Pancon will deliver an enhanced version of their .156" (3.96mm) centerline MAS-CON® headers.

- The enhancements include a higher temperature rated plastic material that is black in colour.
- Plating specifications will not be affected.
- There will not be a change in existing part numbers.

.156" (3.96mm) Mascon flat Header 2 to 24 position MFXS156-XX

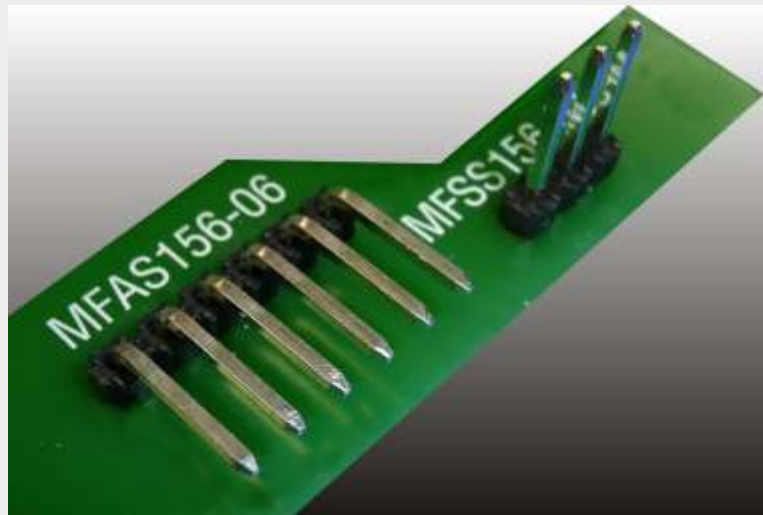
- This series of the product line will not include any physical geometry changes, but will utilize the higher temperature rated plastic material.

.156" (3.96mm) Mascon Tab Polarized & Locking Header 2 to 24 position  
MPxS156-xx & MLxS156-xx

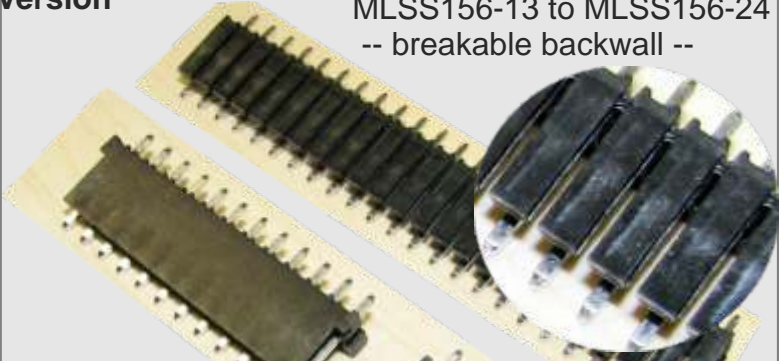
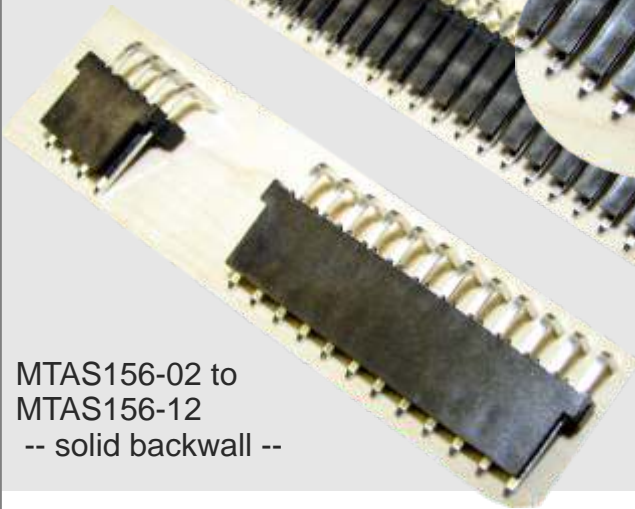
MLSS156-xx & MLAS156-xx:

- polnumbers 2 through 12 are being replaced by MTSS156-xx & MTAS156-xx
- polnumbers 13 through 24 are not changed

MPSS156-xx & MPAS156-xx:

- These products are being replaced by the new ML-types as stated above.
